# City of Santa Fe, New Mexico

# memo

2025-011227-HDRB, 925 Canyon Rd., Downtown & Eastside Historic District, non-contributing, Trey Jordon, agent for John and Mary Ann Vigil and Concepcion Lujan, owners, requests a status review with primary façade designation, if applicable.

Figure 3: Construction Dates

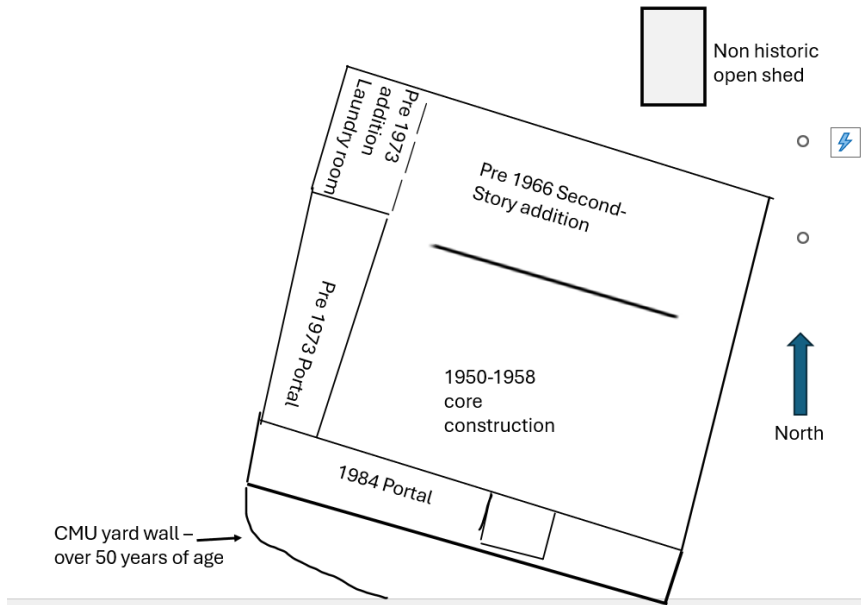
Staff disagree with the HCPI recommendation. All of the additions on the property are historic outside of the portals. The original 1950s adobe section of the building has deep inset fenestrations and is characteristic of the buildings on this streetscape. The additions with two stories at the base of the hill are typical of the time these additions were constructed and are characteristic of this streetscape. Staff finds that this structure is contributing to this streetscape.

Figure 4: Façade Diagram

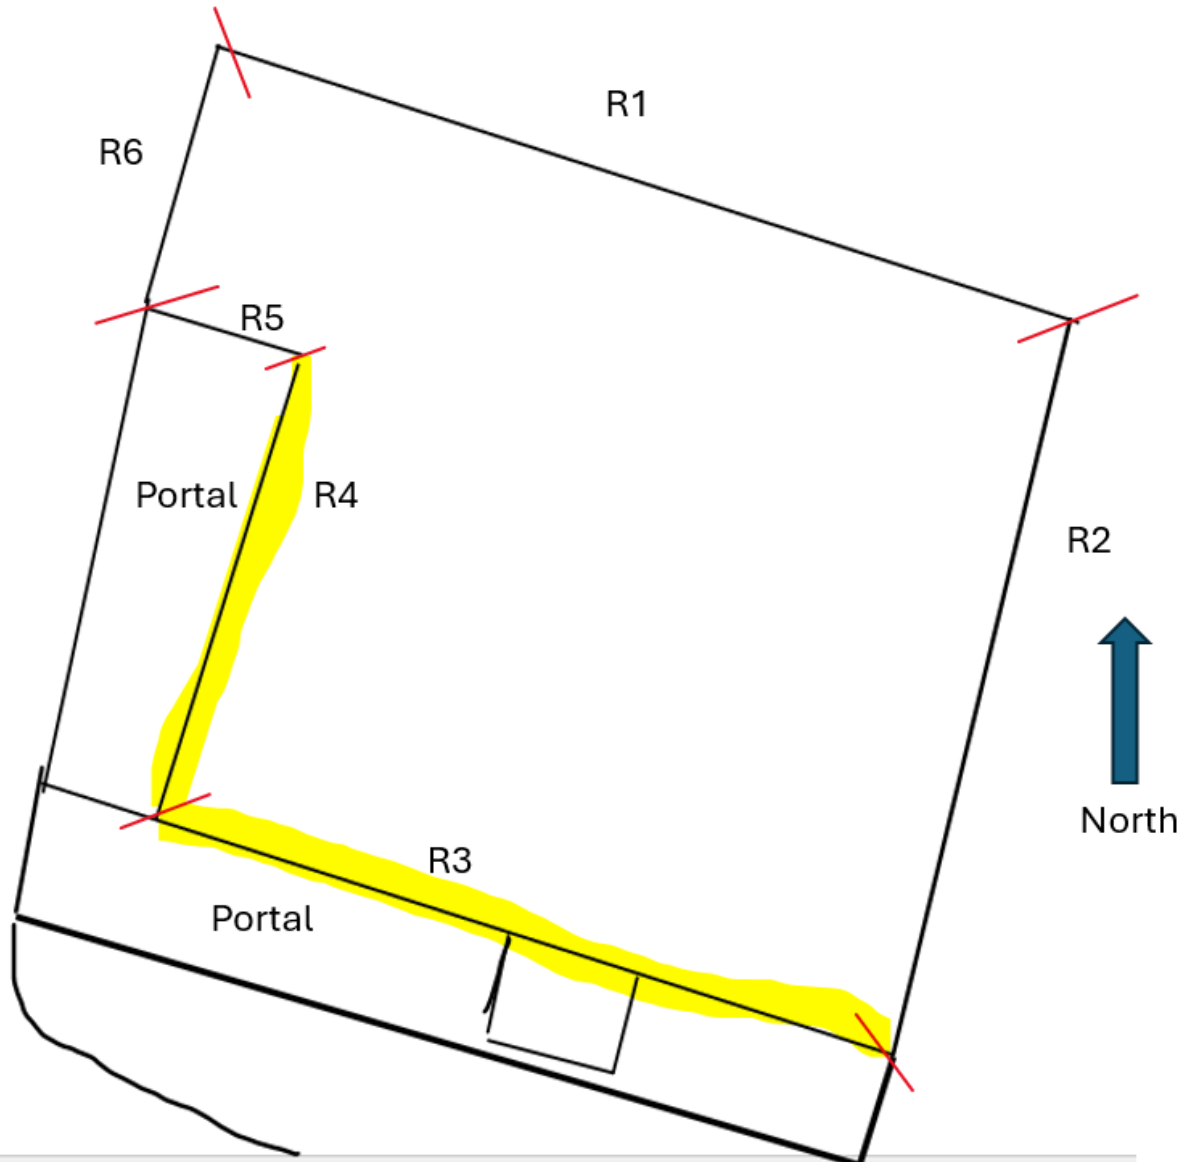
Staff recommends the historic status of the structure be upgraded to contributing with the south and west façades of the original 1950s building as primary (R3 and R4), excluding the non-historic portal, per 14-5.2(C) Designation of Significant, Contributing or Noncontributing Status Within Historic Districts.
